SEWAGE DISPOSAL SYSTEM

SUBDIVISION Boka Valley Estates LOT 3 ROAD 1825 Boka Valley Court

RE: House Relocation
Boka Valley Lot 3
1825 Boka Valley Court

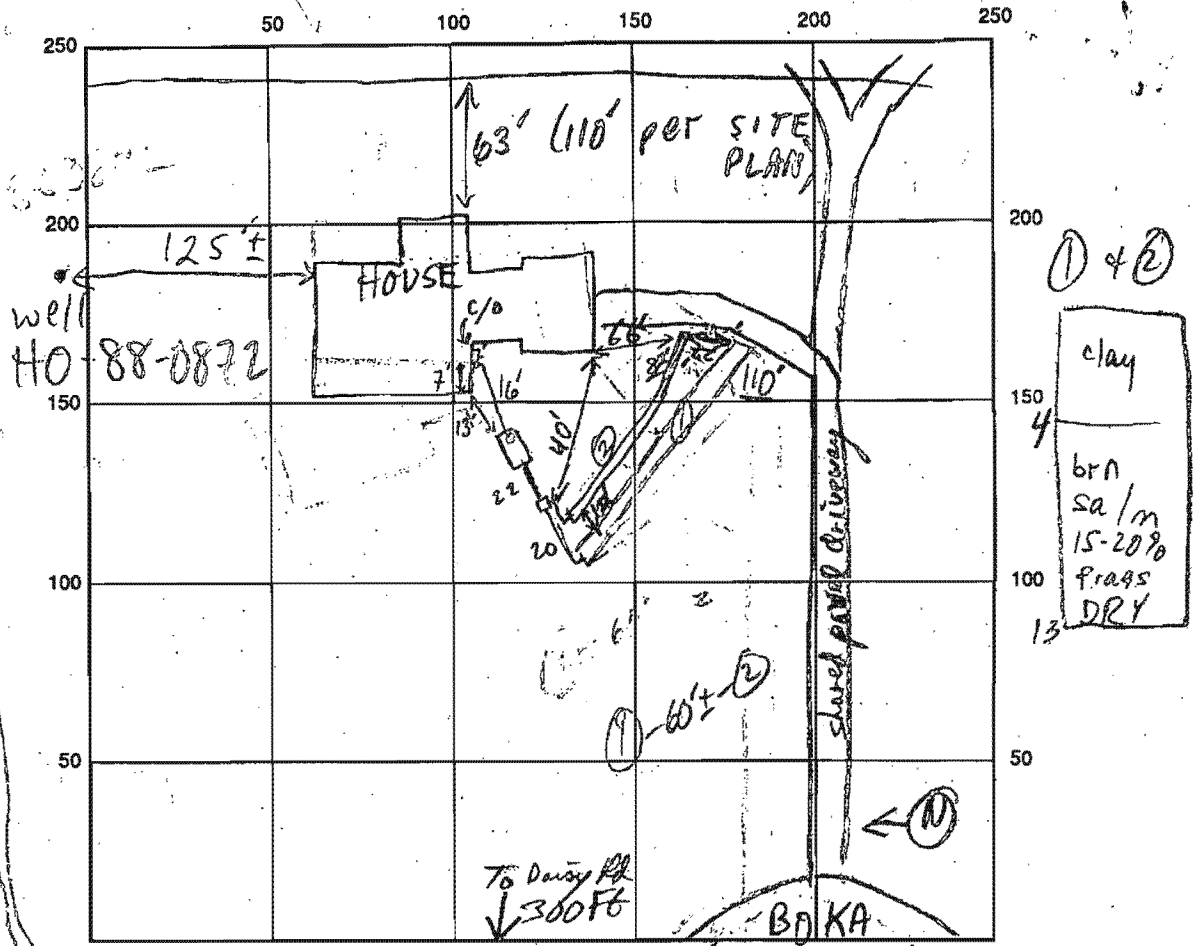
REMARKS: 2/16/94 #1 HOUSE LOCATION MOVED 50' E UPHILL FROM SITE PLAN LOCAT 10N;
DRIVEWAY ALSO REVERSED FROM SITE PLAN LAYOUT, BUT NO IMPACT TO
SDA DUE TO HOUSE RELOCATION; SDA ALSO APPEARED "LOW" BUT HOLES
CONFIRM - OK; IMR 3/16/94 OK TO STONE TRENCH (1), DIG (2) MR
OK to cover lot trench, OK to gravel fill second. OK to cover system 3/17/94
with a line, pull boxes, covered OK by IMR on 3/16
